Re: Eagle Technology
3821 Singer NE Albuquerque NM
Traffic Circulation Layout
Engineer's/Architect's Stamp 01-06-20 (F17D058)

Based upon the information provided in your submittal received 02-04-20, the above referenced plan cannot be approved for Building Permit until the following comments are addressed:

ARCHITECTURAL
SITE PLAN
DEMO SITE PLAN
TRAFFIC CIRCULATION LAYOUT
FIRE 1 PLAN

AS101/TCL/FIRE1

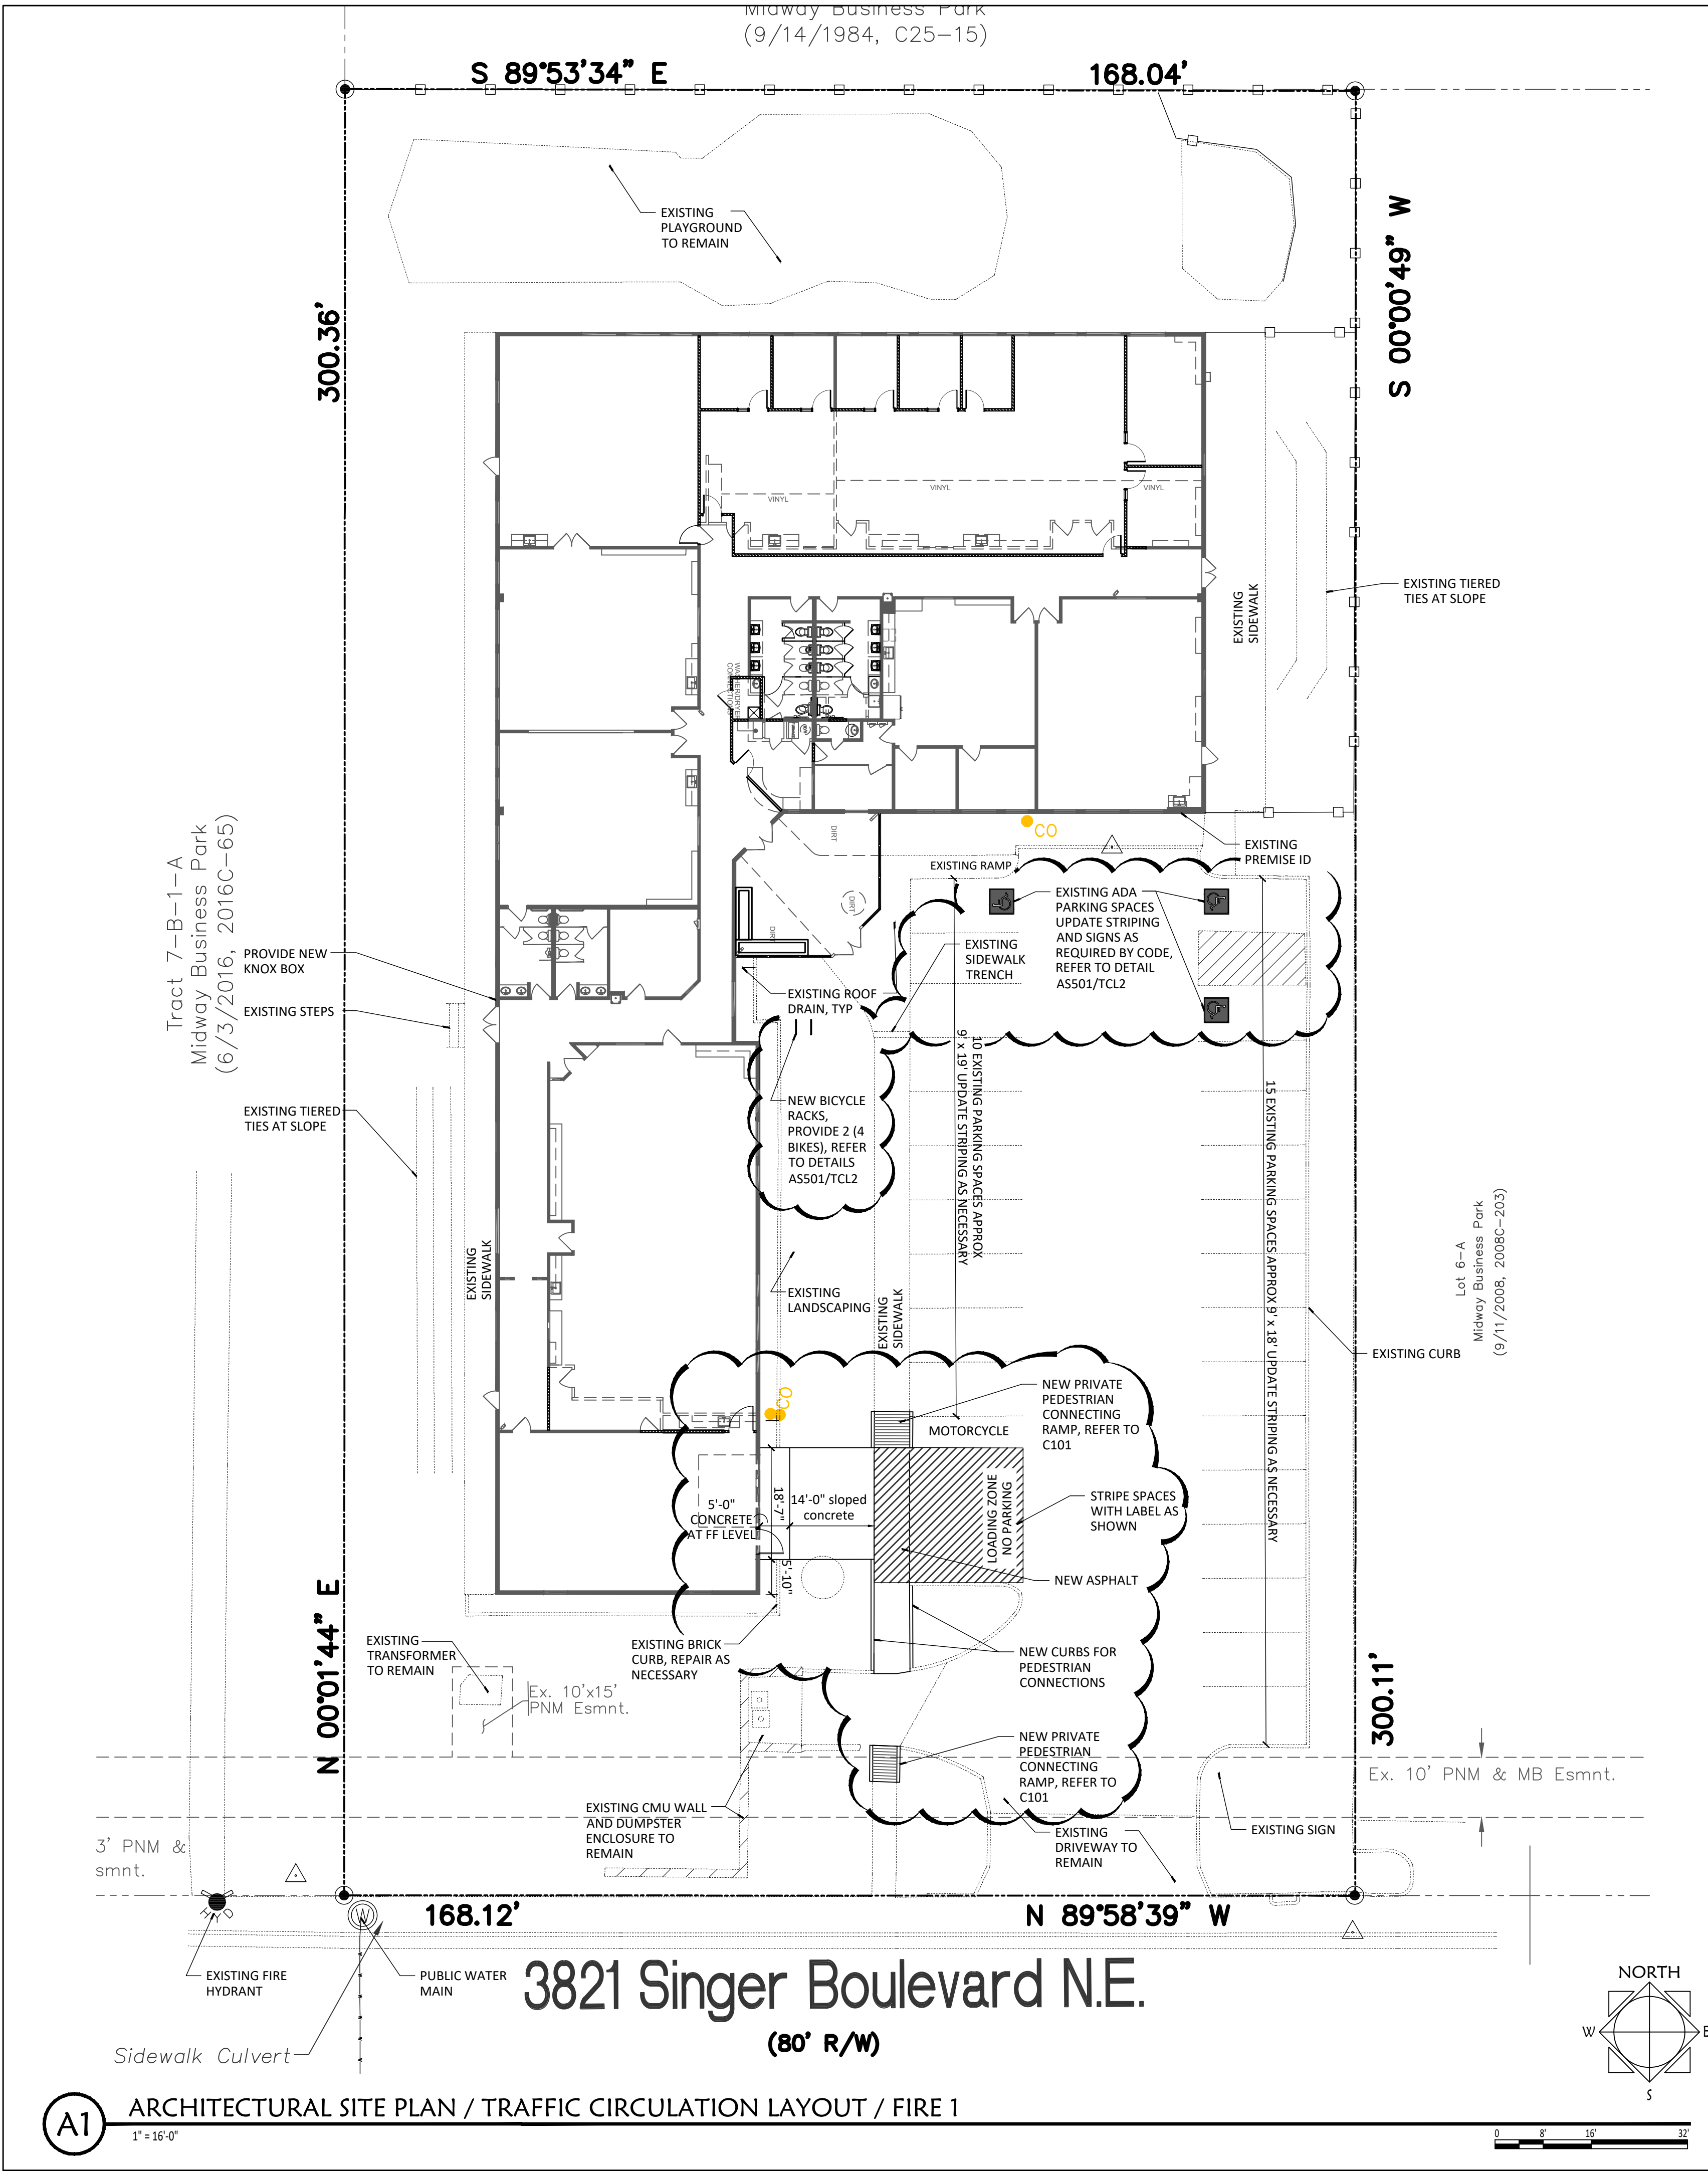
1. The ADA accessible spaces must include an access aisle. Van accessible aisles should be 8ft wide; all others should be 5ft wide.
2. The ADA accessible parking sign must have the required language per 66-7-352.4C NMSA 1978 **"Violators Are Subject to a Fine and/or Towing."** Please call out detail and location of signs. **Please show the details.**

3. The ADA access aisles shall have the words **"NO PARKING"** in capital letters, each of which shall be at least one foot high and at least two inches wide, placed at the rear of the parking space so as to be close to where an adjacent vehicle's rear tire would be placed. (66-1-4.1.B NMSA 1978)

4. Motorcycle parking spaces shall be designated by its own conspicuously posted upright sign, either free-standing or wall mounted per the zoning code.

5. Show bike rack details.
6. A 5 ft. keyway is required for dead-end parking aisles.
7. Per DPM, a 6 ft. wide ADA accessible pedestrian pathway is required from the ADA parking stall access aisles to the building entrances. Please clearly show this pathway and provide details.

8. Please remove all clouds.
